**Re - Casey Fields South (Employment) and Devon Meadows
Precinct Structure Plan
165 – 215 Clyde Five-Ways Road, Clyde**

KLM Spatial acts on behalf of Galileo Clyde Fiveways Pty Ltd in providing the following response to the exhibited Draft Casey Fields South (Employment) and Devon Meadows Precinct Structure Plan ('the PSP'). Galileo Group is an independent Australian development group with many successful greenfield developments in Melbourne's south-east.

1. After Plan 2 – Place Based Plan - as amended by KLM Spatial
2. After Plan 2 – Place Based Plan with contours - as amended by KLM Spatial

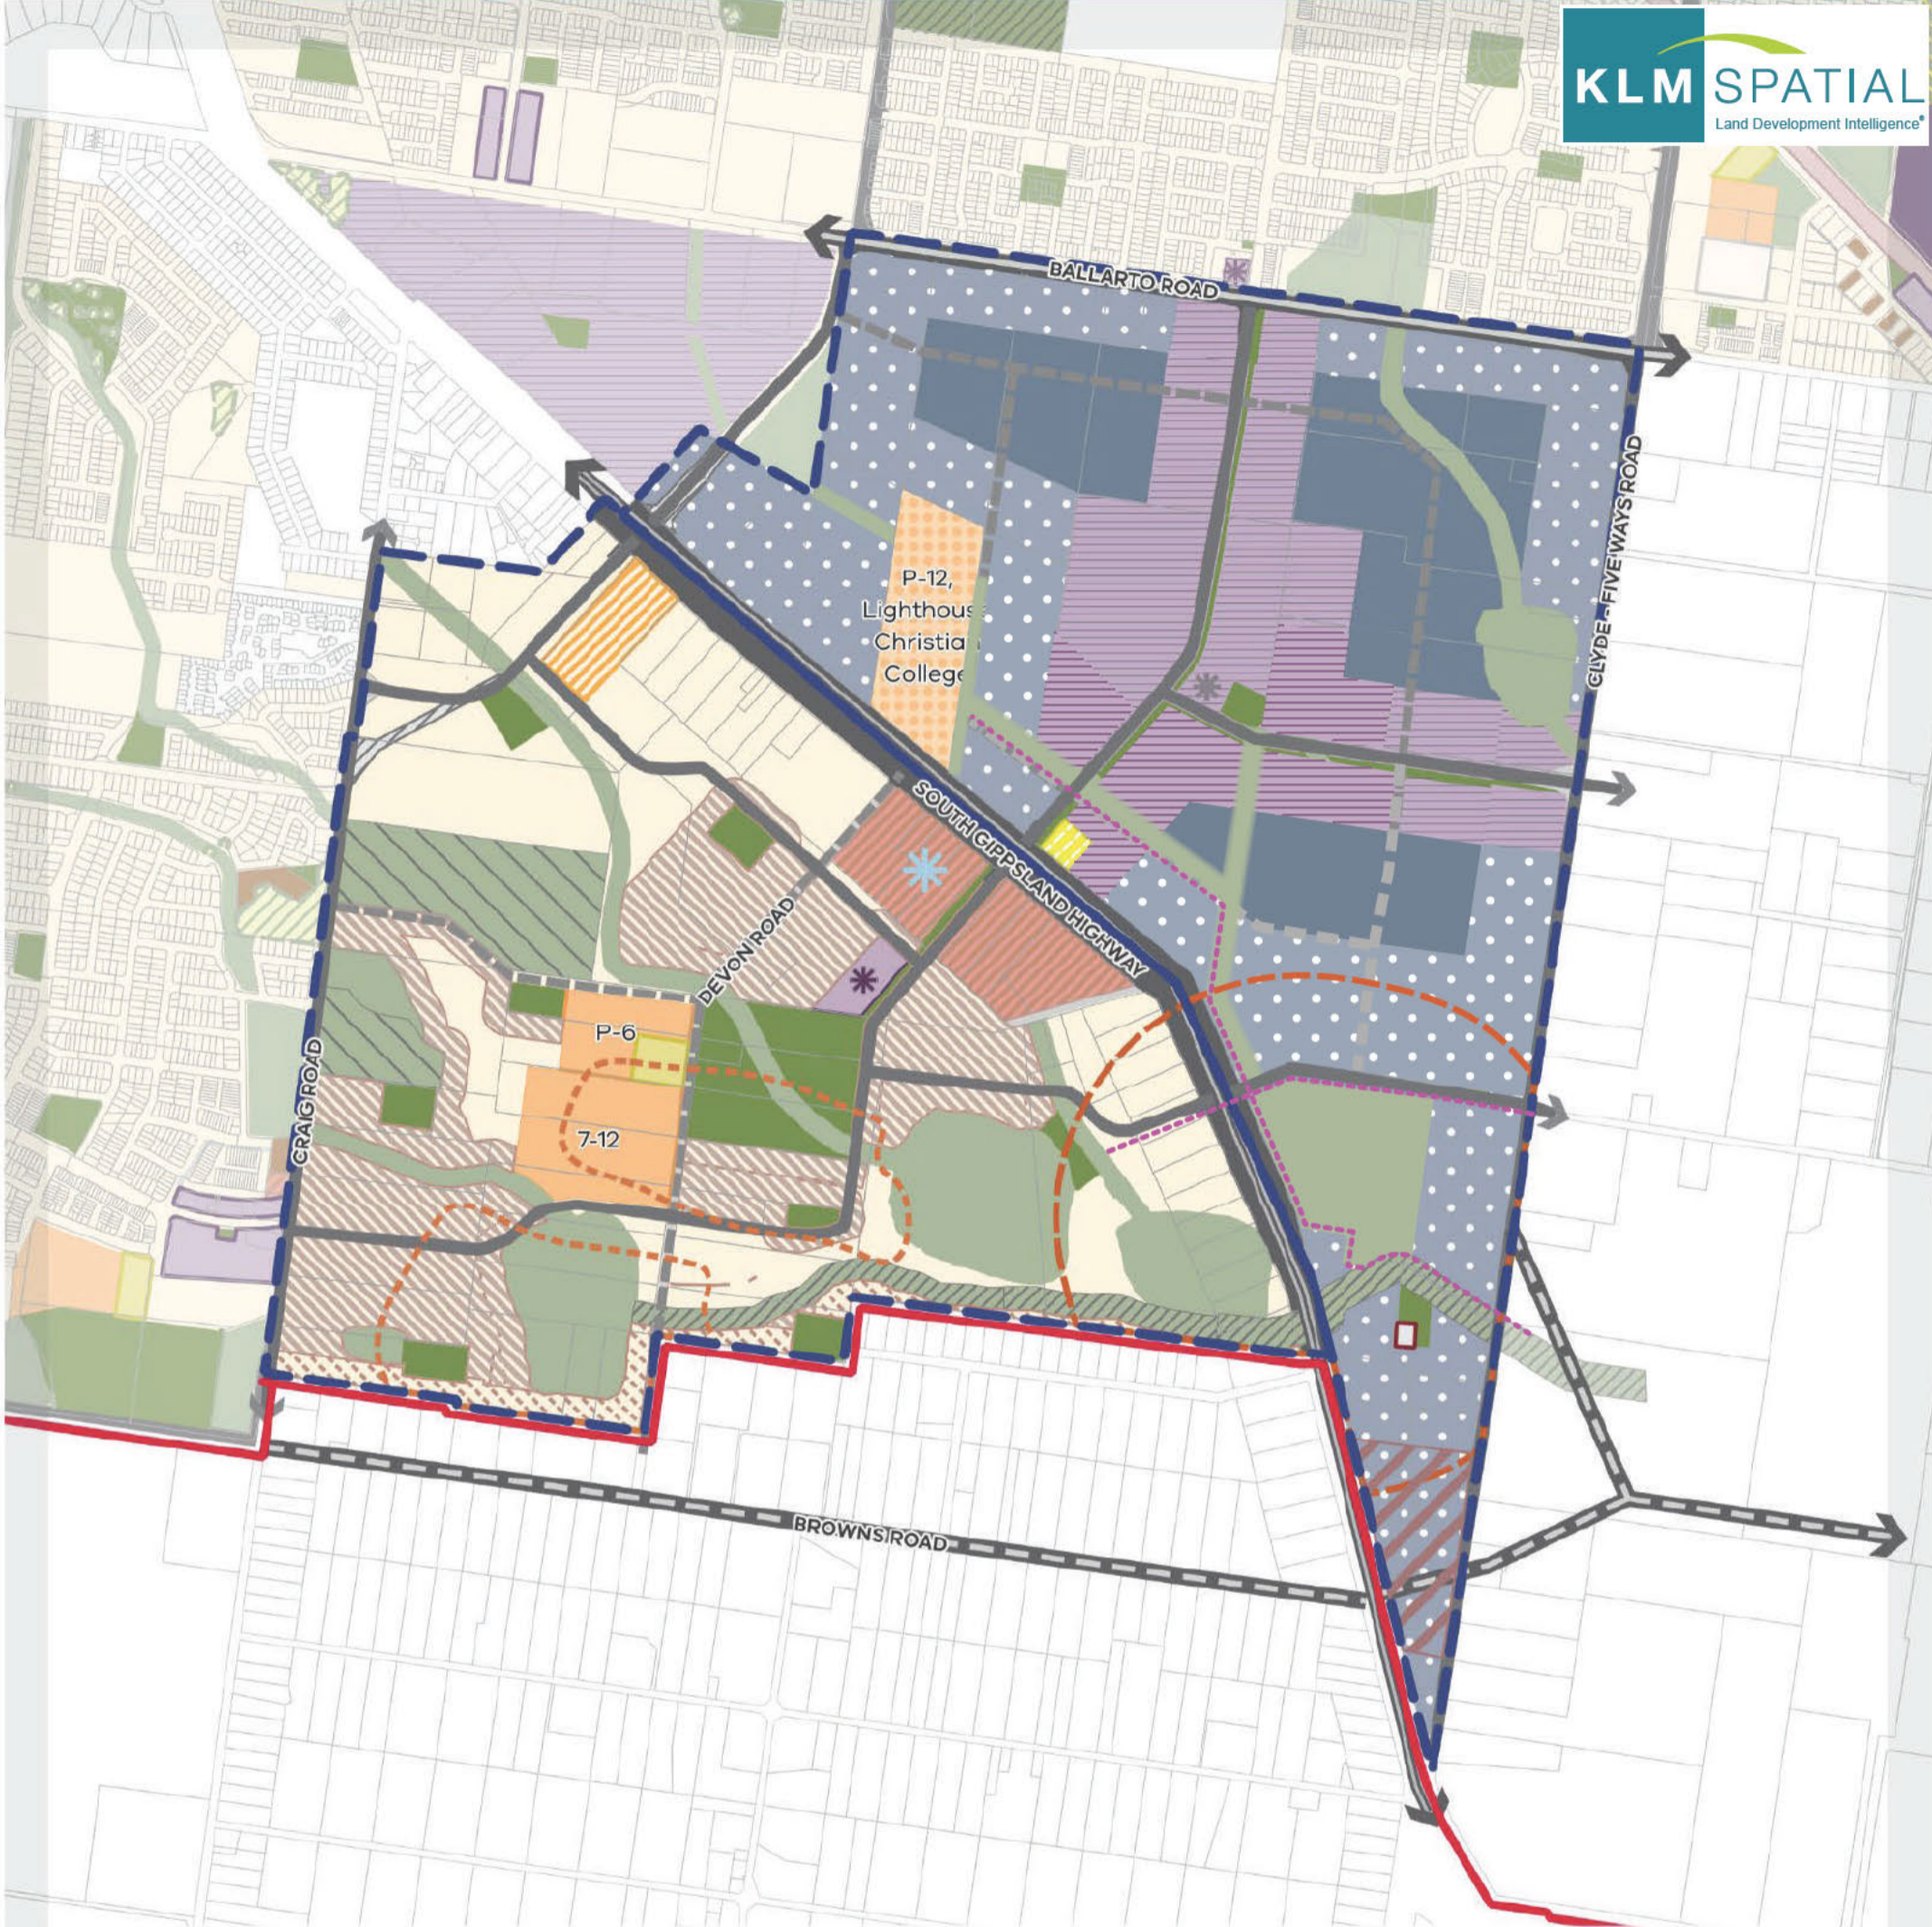
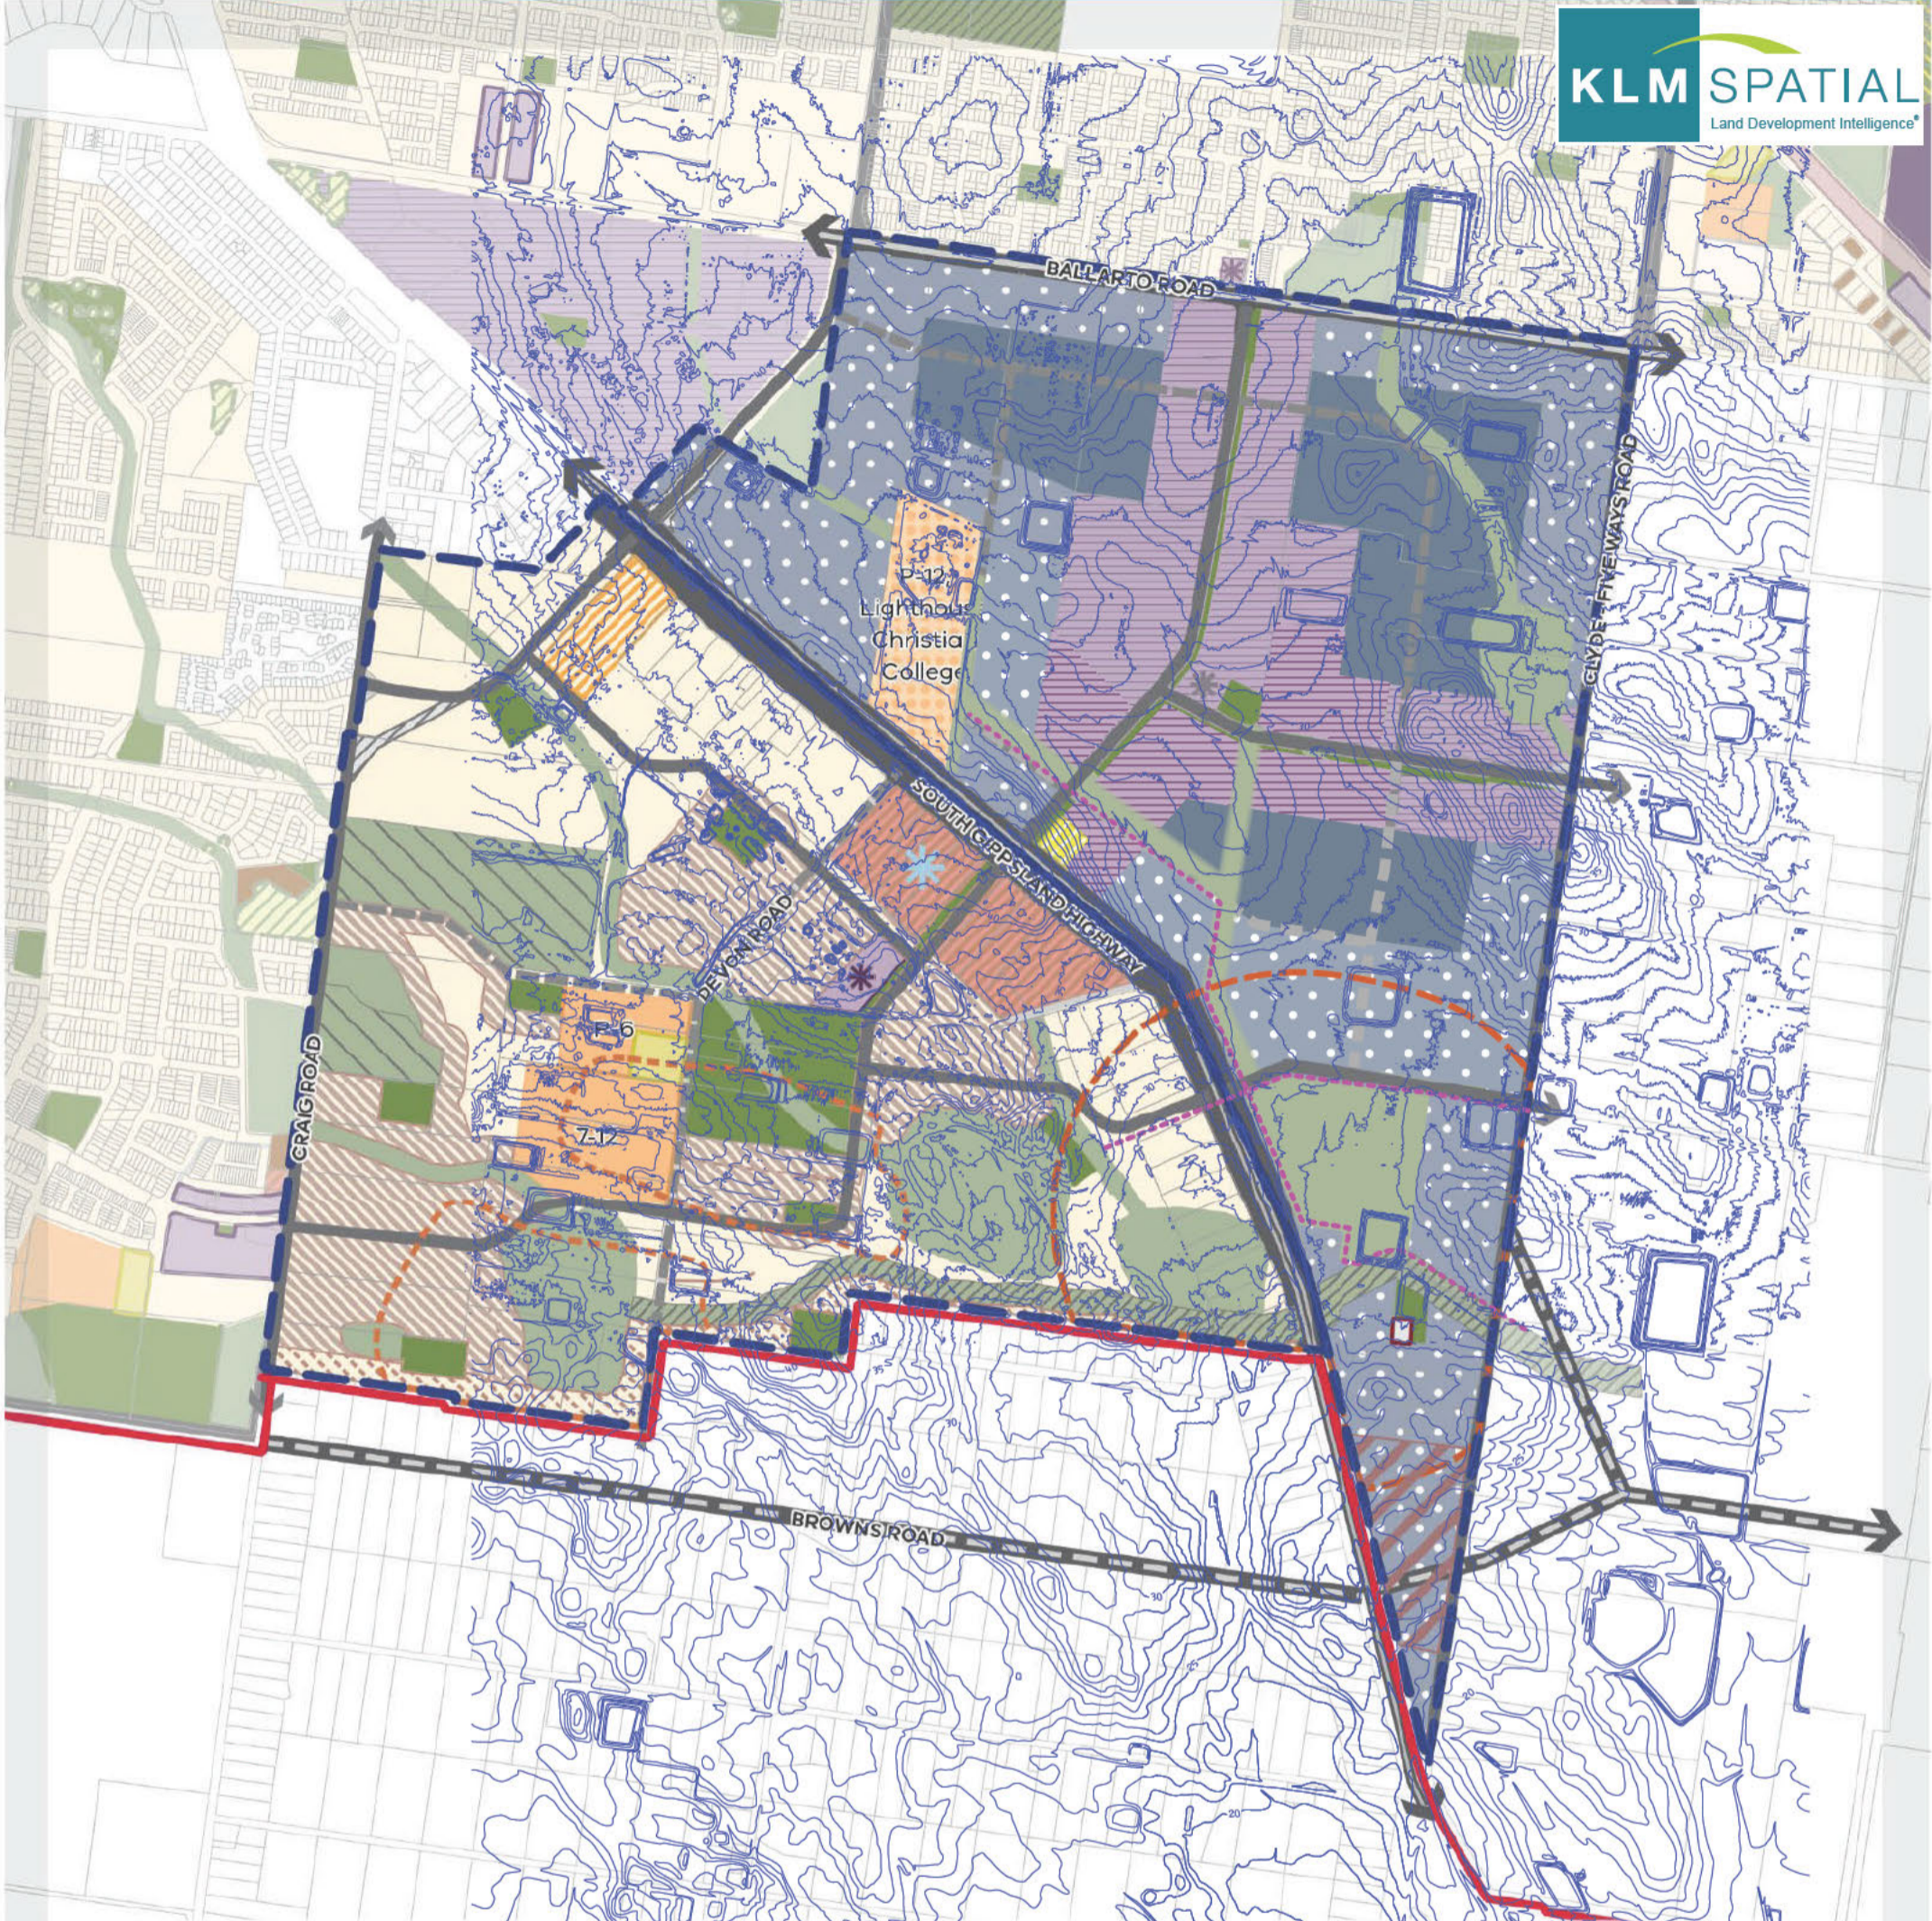
1. All PSP Plans 1-13 be amended to incorporate the alternative wetland and waterway configuration
2. Plan 6 Water - delete wetlands RB_01, RB_02 and RB_05
3. Plan 6 Water – Identify the alternative efficient wetland as RB_01
4. Plan 9 Infrastructure and Development Staging - Delete Outlet 02 and renumber Outlet 03
5. Table 8 Water Infrastructure – to be amended to reference to appropriate descriptors for the alternative scheme (alternative table to be provided separately)
6. Amend R8 to delete referenced documents and instead state,
